# 1992 - 1993 Corvette: Service Bulletin: Cracks/Damage to Cowl Surface

**Subject:** CRACKS OR DAMAGE TO COWL SURFACE

**Model and Year:** 1992-93 CORVETTE WITH RPO LT1 ENGINES ONLY

**Bulletin Number:** 93-134-10

FIGURE 1

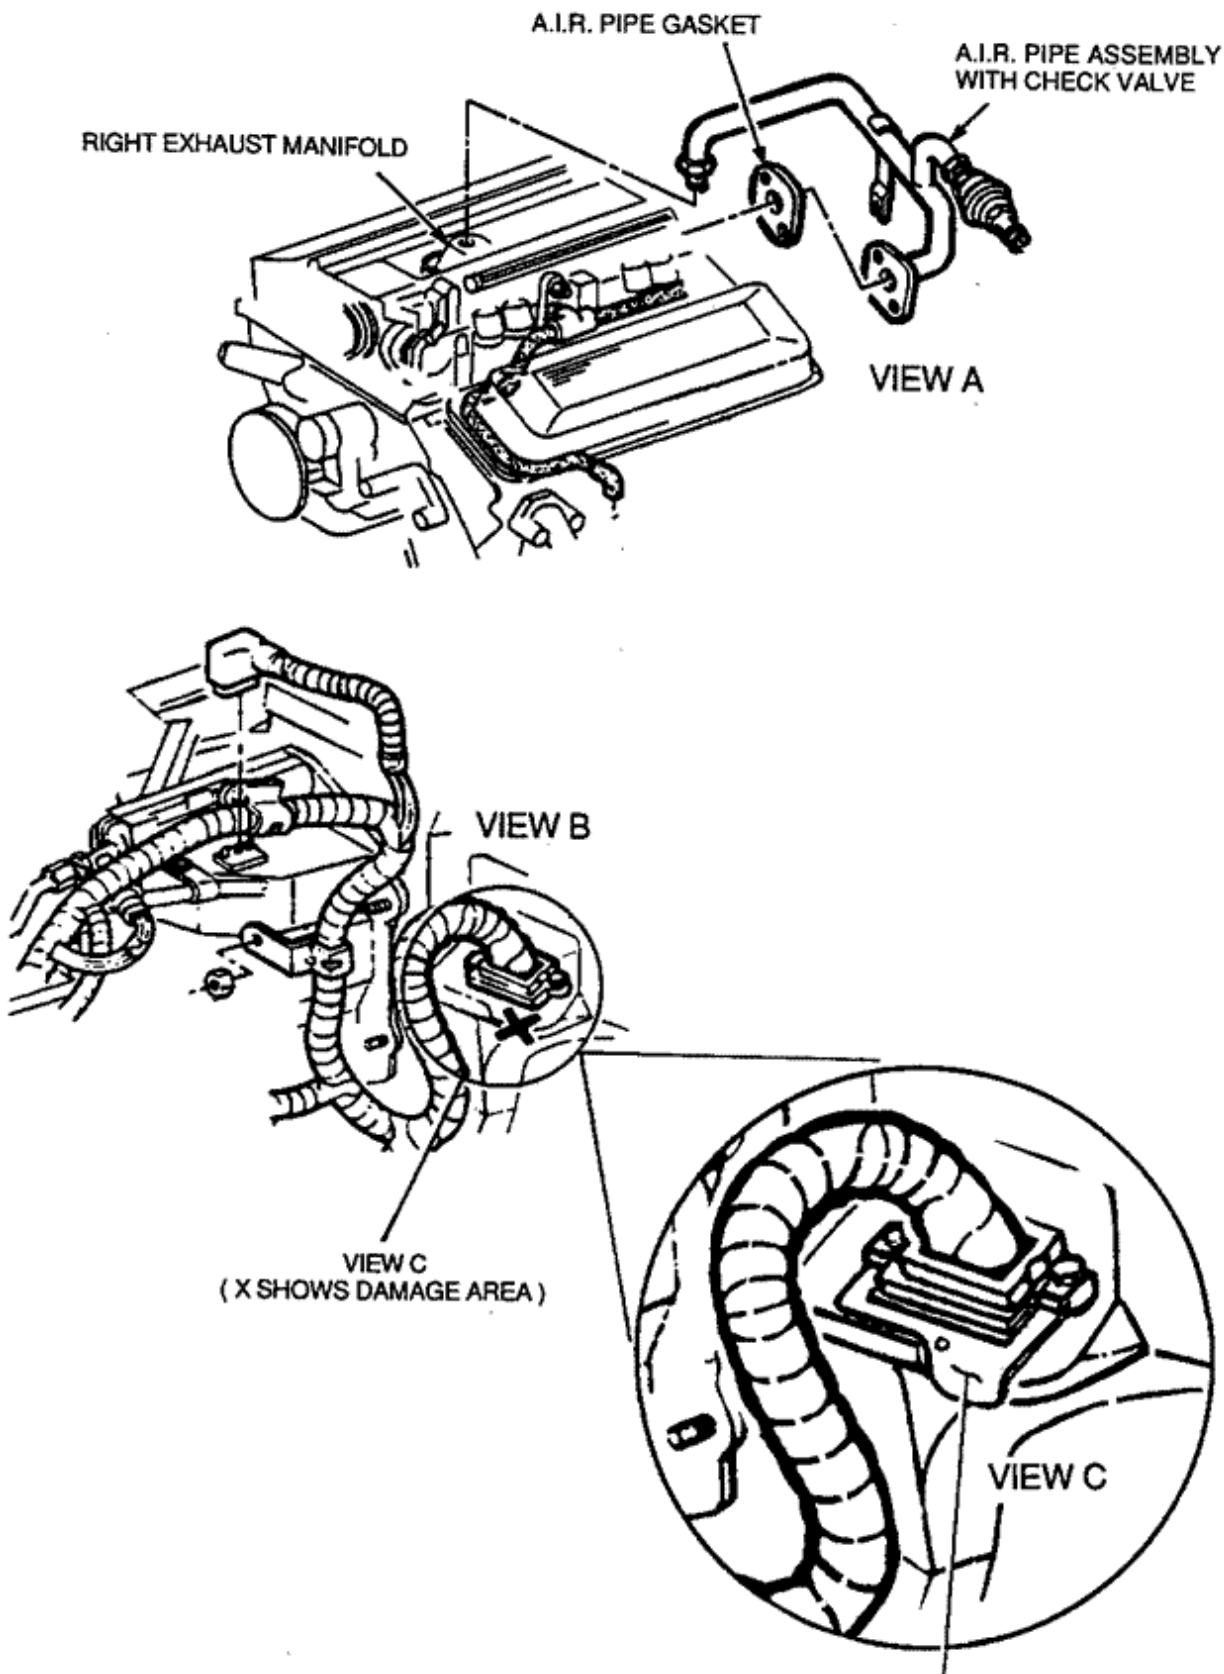
Some 1992-93 Y-cars with LT1 engines may have cracks or damage to the cowl surface:

- Behind the right cylinder head, - Below the wiring harness connector.

Rear of engine may contact the cowl surface when removing transmission or engine from vehicle.

4. Remove right side A.I.R. pipe from engine (See View A);
  - a. Remove nut at exhaust manifold, use 22 mm "crow foot" wrench.
  - b. Loosen bolt on rear of head, using long 9/16" open end wrench.

- c. Remove bolts on rear of intake manifold, use 10 mm 1/4" drive socket and flex extension.
  - d. Remove hose and plastic clamp from check valve.
5. Clean damaged area (See View B) with a wax and grease remover and use V.O.C. approved materials where required.

6. Apply enough seam sealing material to fill or cover the damaged area. Paddle material into place, if required.
7. Loosen the harness connector attaching bolts, position GM P/N 10231336 - Spacer, over the damaged area and under the attaching bolt heads and tighten the attaching bolts. The spacer has slots to aid in installation (See View C).

NEW PART IN POSITION OVER DAMAGED AREA
